1 ELEVATION NORTH - REMEDIATION MARK-UP Copy 1
1:100

2 ELEVATION SOUTH - REMEDIATION MARK-UP Copy 1
1:100

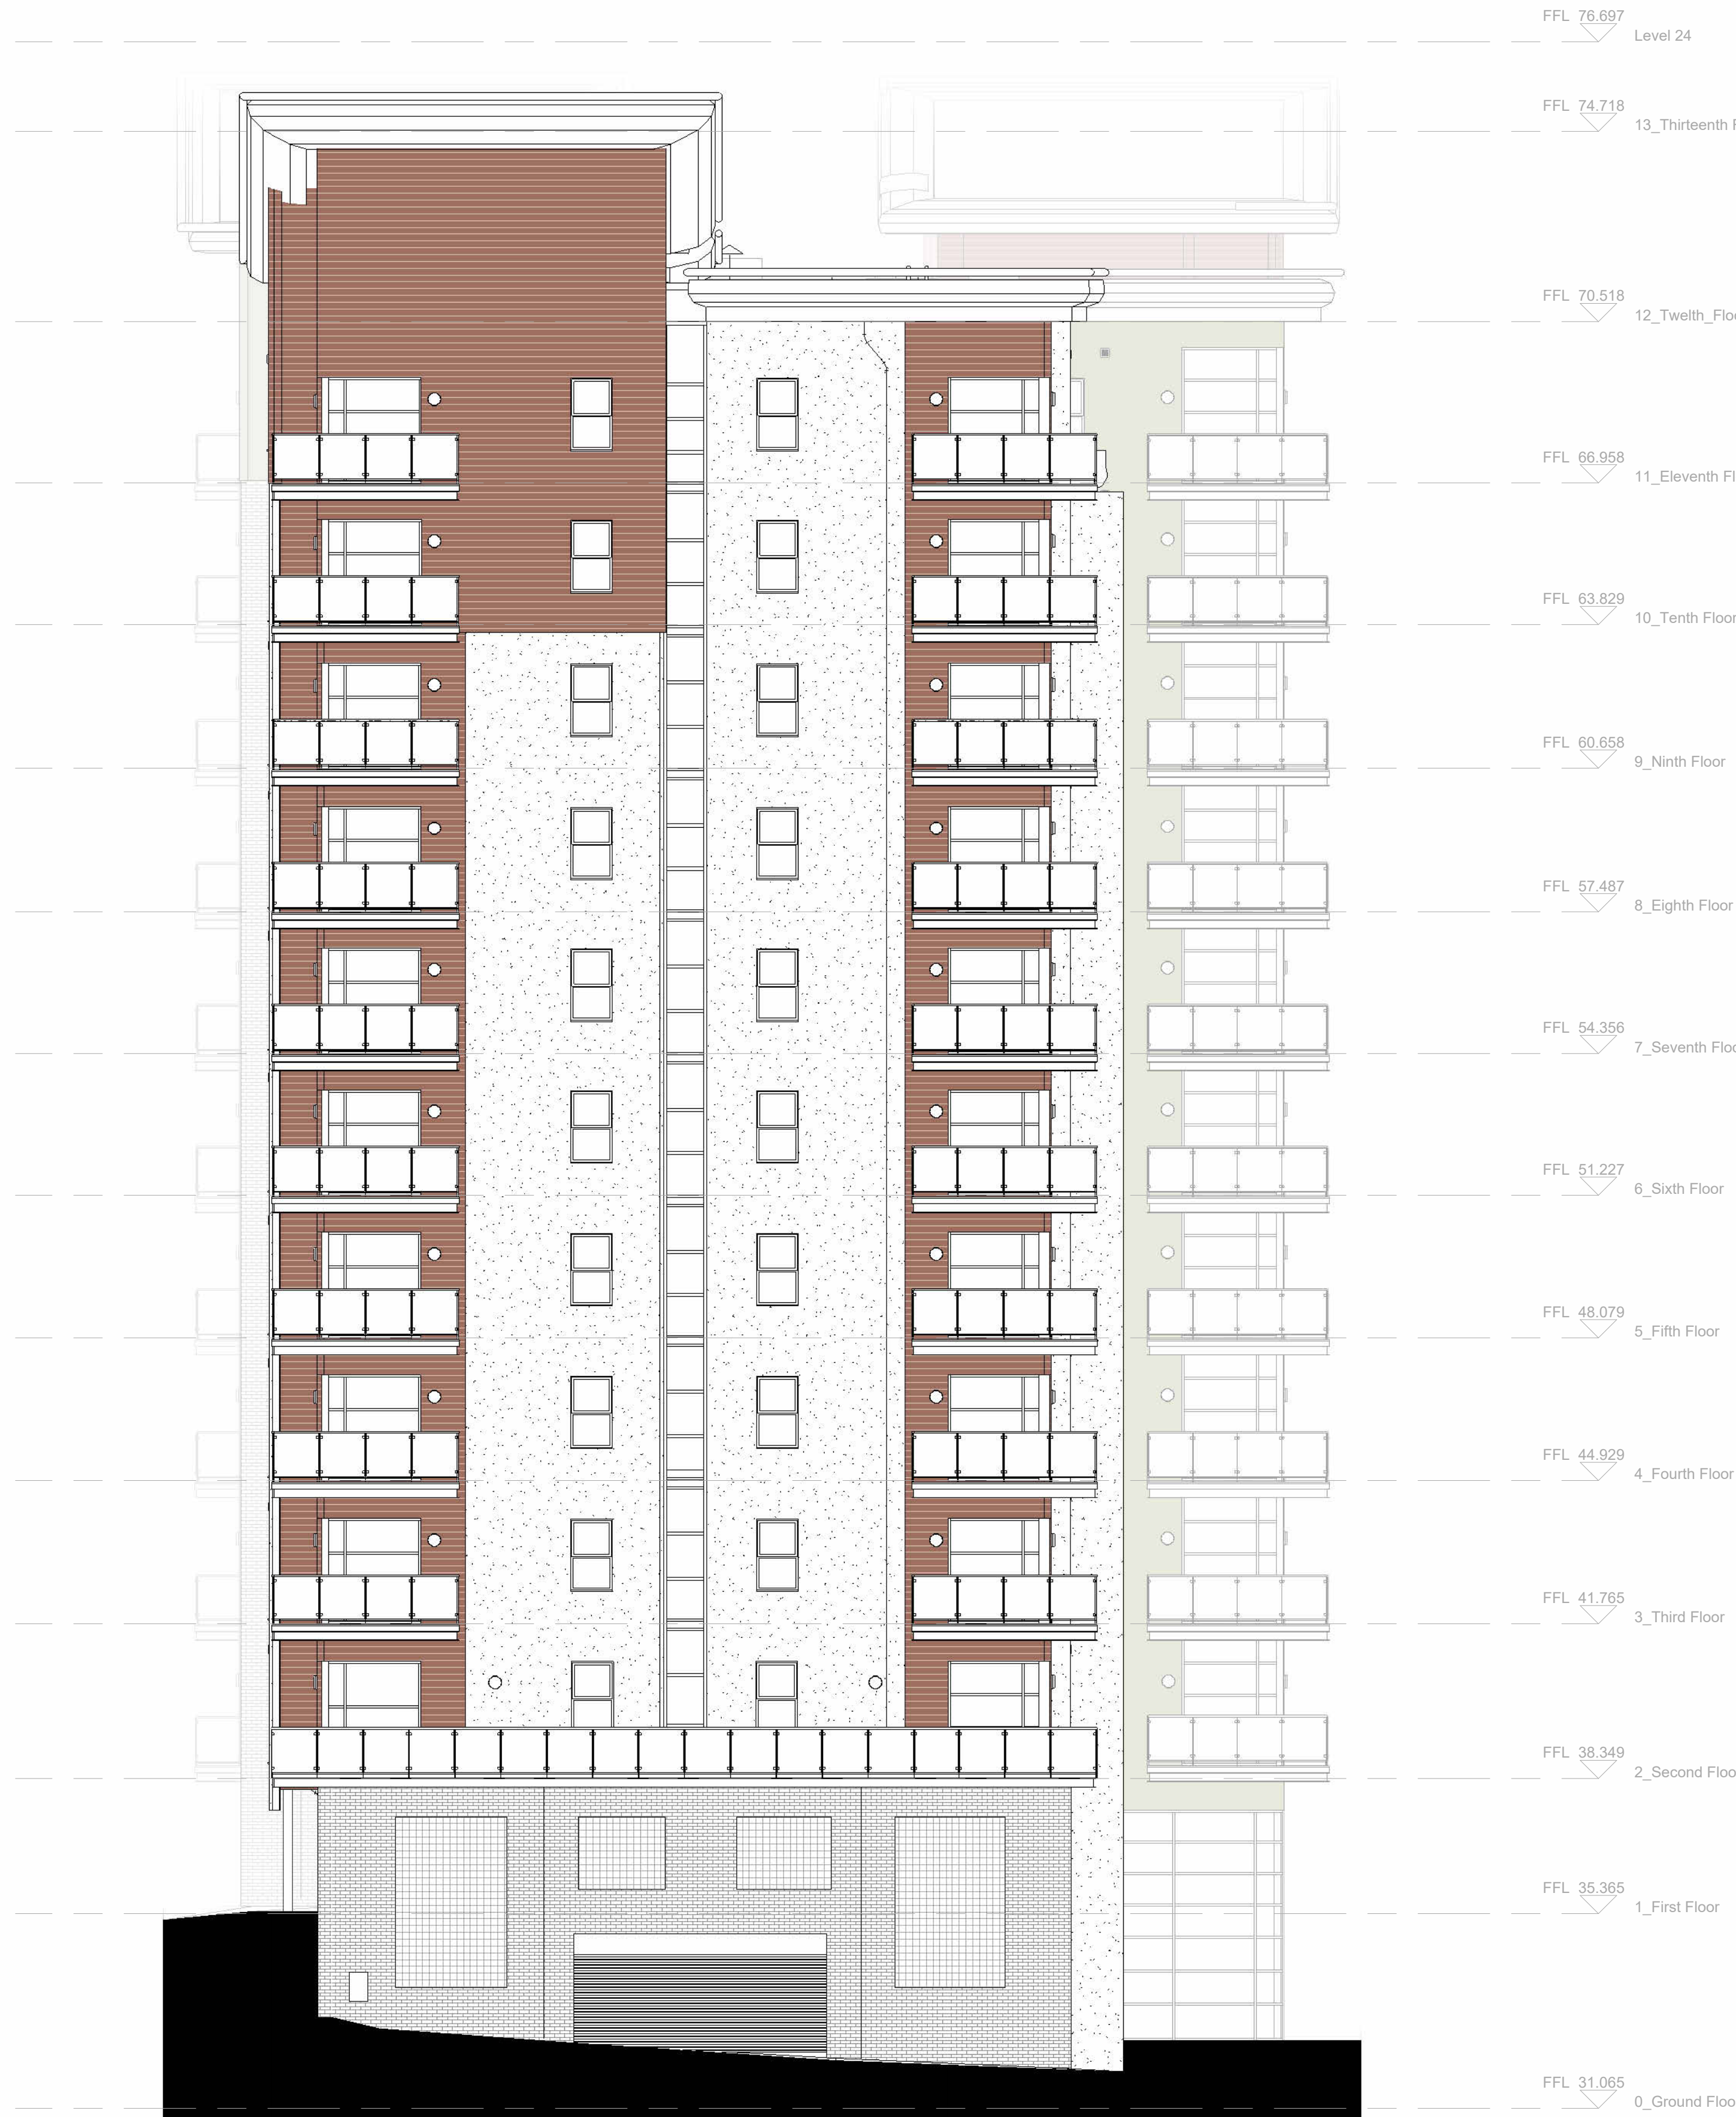
NB: Should timber decking need to be removed in order to remediate the external walls, it will be the view of the BCO and/or BSH whether this is considered enabling works or a material alteration which may result in any new products to be Regulation 7 compliant.
